MITSUBISHI MOTORS

SERVICE BULLETIN

PURPOSE : INFORMATION	ISSUE NO. : MSB-12EX00-001	DATE : 2012-06-20	
SUBJECT : INFORMATION ON 2013 ASX		<Destination/Model> (EUR/RUSSIA/SOUTH AFRICA) ASX(GA0W)	<M/Y> 13
GROUP : GENERAL

This Service Bulletin contains the information about the 2013 ASX Body Repair Manual.

Dash panel

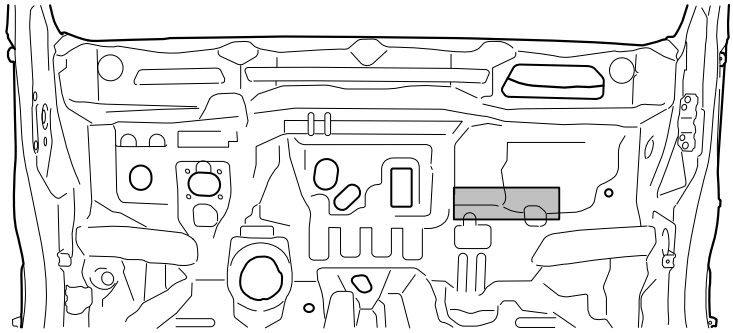
The application locations of the silencer have been changed.

VEHICLES FOR RUSSIA

NOTE:
: 2.5 mm film thick spray-type anti-vibration agent. (Place two 1.6 mm melting sheet one on top of another.)
: 5.0 mm film thick spray-type anti-vibration agent. (Place four 1.6 mm melting sheet one on top of another.)
( ) indicates the number of 1.6 mm thick melting sheets that are used for repair.
